Access Compliance Report

Public Rights-of-Way

Intersection ID: 50341	Main Street: SCONE_PALACE_CT	Cross Street: CASTLECOVE_RD	Location: NW
ADA ID: A38F36A88A02	Ramp Type: Perp	Initial Pass/Fail: Fail	Overall Compliance: No
Severity Score: 8.75			
Codes/Mitigation Info/Possible Solution		Field Measurements/Component Compliance

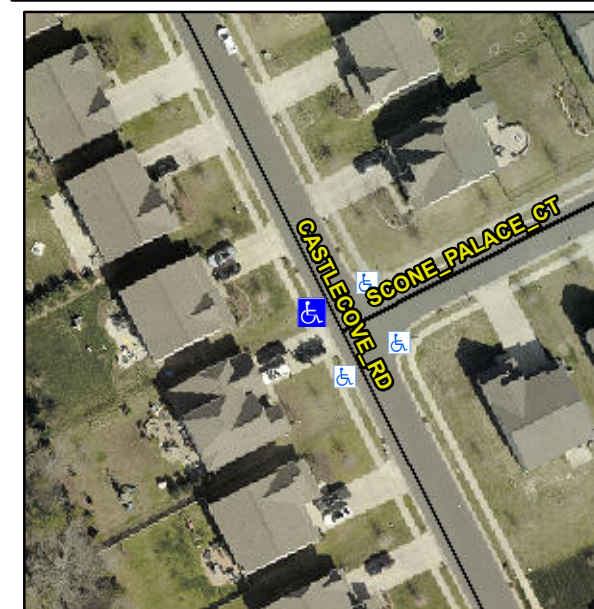
Not Found, R304.5.1

Compliance	Description	Data	Compliance	Description	Data
N/A	Ramp Length (in)	47.0	Yes	Ramp Slope (%)	5.1
No	Ramp Width (in)	47.0	Yes	Ramp XSlope (%)	1.9
N/A	Flare Type LT	N/A	N/A	Flare Type RT	N/A
N/A	Flare Slope LT (%)	N/A	N/A	Flare Slope RT (%)	N/A
N/A	Flare Traversable LT?	N/A	N/A	Flare Traversable RT?	N/A
N/A	Landing Length (in)	N/A	N/A	DWS Provided?	N/A
N/A	Landing Width (in)	N/A	N/A	DWS Contrast?	N/A
N/A	Landing Slope (%)	N/A	N/A	DWS Length (in)	N/A
N/A	Landing X Slope (%)	N/A	N/A	DWS Full Width?	N/A
N/A	Landing Curb? (Y/N)	N/A	N/A	DWS Offset (in)	N/A
N/A	Shared Landing?	N/A			
N/A	Gutter Ponding?	N/A	N/A	Gutter Slope (%)	N/A
N/A	Gutter Lip Ht (in)	N/A	N/A	Gutter X Slope (%)	N/A
N/A	Painted X Walk1?	No	N/A	Painted X Walk2?	N/A
	X Walk 1 Direction	To NE		X Walk 2 Direction	N/A
N/A	X Walk 1 Width (in)	N/A	N/A	X Walk 2 Width (in)	N/A
	X Walk 1 Slope (%)	1.3		X Walk 2 Slope (%)	N/A
	X Walk 1 X Slope (%)	1.5		X Walk 2 X Slope (%)	N/A

N/A	Ramp inside XWalk1?	N/A	N/A	Ramp inside XWalk2?	N/A
	Road Slope (%)	N/A	N/A	Clear Space?	N/A
	Road X Slope (%)	N/A	N/A	Clear Space to XWalk (in)	N/A
N/A	Any Obstructions?	N/A	N/A	Storm Grate/Utility Hazard?	N/A
	Obstruction Type			Storm Grate/Utility Type	
		N/A			N/A
			Yes	Surface Condition? (G/P)	Good

Remove & Replace Entire Ramp.
